November 26, 1976

Dockets Nos.: 50-280  
and 50-281 ✓

The Commission has issued the enclosed Amendments No. 26 to Facility Operating Licenses Nos. DPR-32 and DPR-37 for the Surry Power Station Units Nos. 1 and 2. The amendments consist of an added condition to the license for Surry Unit No. 2 and changes to the Technical Specifications in partial response to your application dated September 27, 1976, as supplemented October 29, 1976, and your submittals dated October 19, 1976, and November 15, 1976. We did not include any revisions in your Technical Specifications related to the Nuclear Enthalpy Rise Hot Channel Factor (**EH**); hence, you should continue to operate Surry Unit No. 2 under the existing Technical Specifications for **EH** and the additional restrictions of your August 16, 1976 letter (Serial No. 186).

ATTACHMENT TO LICENSE AMENDMENT NO. 26

HOT CHANNEL FACTOR NORMALIZED  
OPERATING ENVELOPE

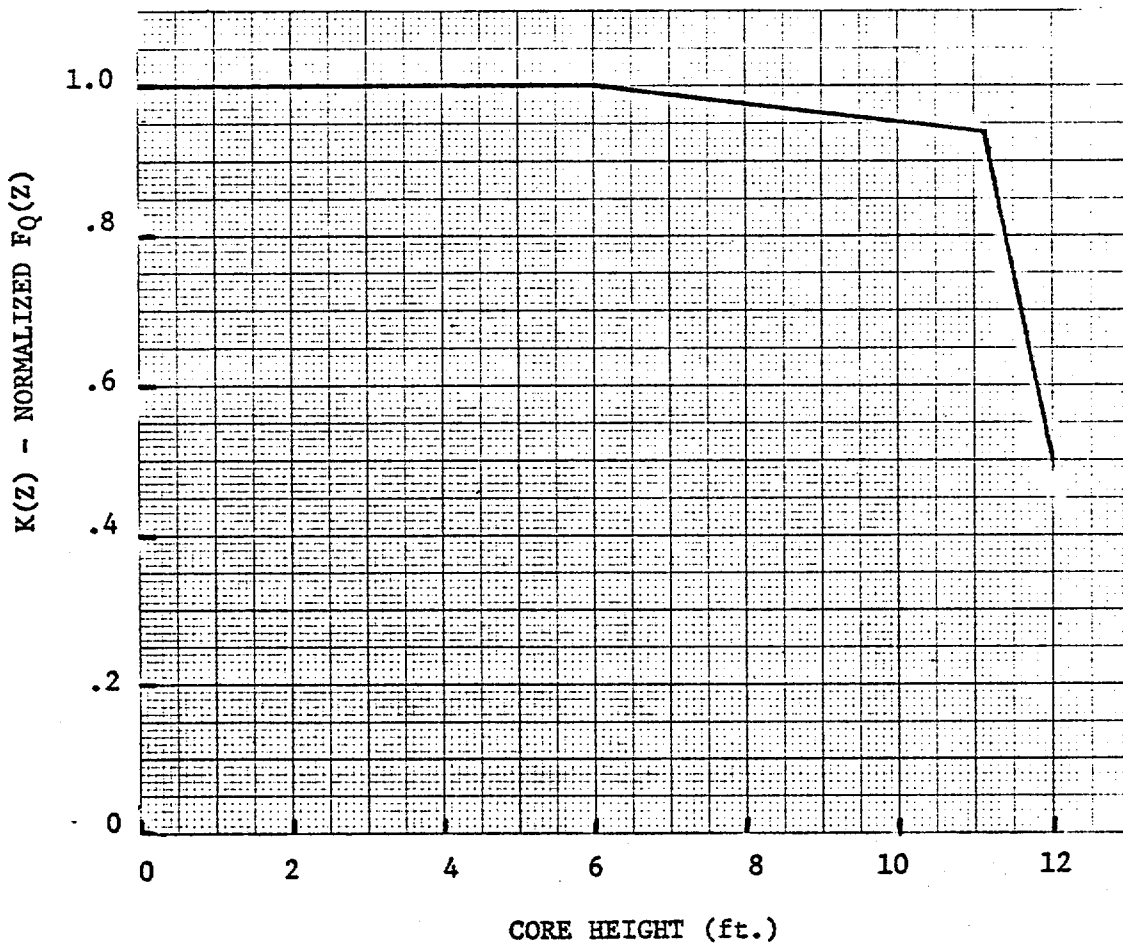
where P is the fraction of rated power at which the core is operating, K(Z) is the function given in Figure 3.12-8, Z is the core height location of  $F_Q$ .

The results of the loss of coolant accident analyses are conservative with respect to the ECCS acceptance criteria as specified in 10 CFR 50.46 using an upper bound envelope of 2.00 times the hot channel factor normalized operating envelope of TS Figure 3.12-8.

$$F_Q(Z) \leq (2.00/P) \times K(Z) \text{ for } P > .5$$

$$F_Q(Z) \leq (4.00) \times K(Z) \text{ for } P \leq .5$$

$$F_{\Delta H}^N \leq 1.55 (1 + 0.2(1 - P))$$

HOT CHANNEL FACTOR NORMALIZED  
OPERATING ENVELOPE

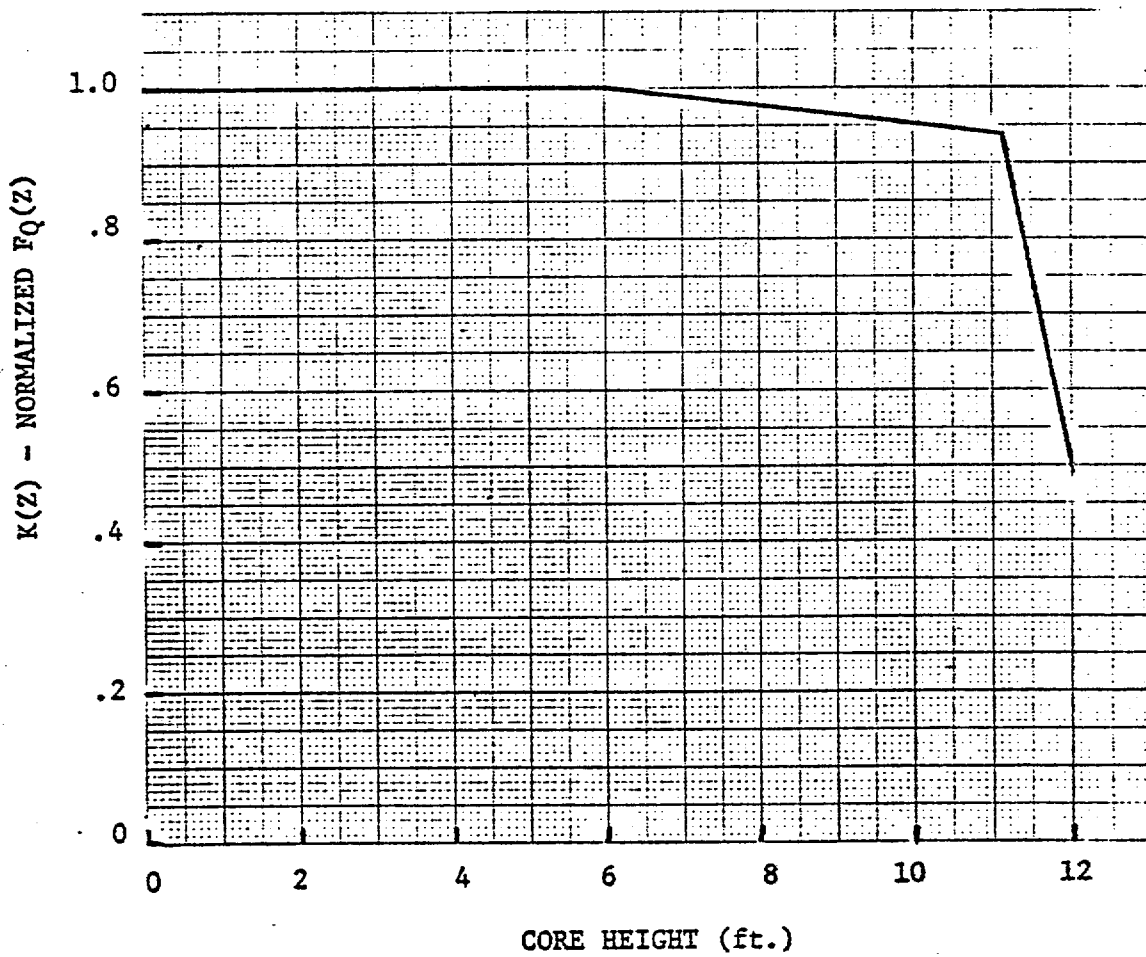
where P is the fraction of rated power at which the core is operating, K(Z) is the function given in Figure 3.12-8, Z is the core height location of F<sub>Q</sub>.

The results of the loss of coolant accident analyses are conservative with respect to the ECCS acceptance criteria as specified in 10 CFR 50.46 using an upper bound envelope of 2.00 times the hot channel factor normalized operating envelope of TS Figure 3.12-8.

$$F_Q(Z) \leq (2.00/P) \times K(Z) \text{ for } P > .5$$

$$F_Q(Z) \leq (4.00) \times K(Z) \text{ for } P \leq .5$$

$$F_{\Delta H}^N \leq 1.55 (1 + 0.2(1 - P))$$
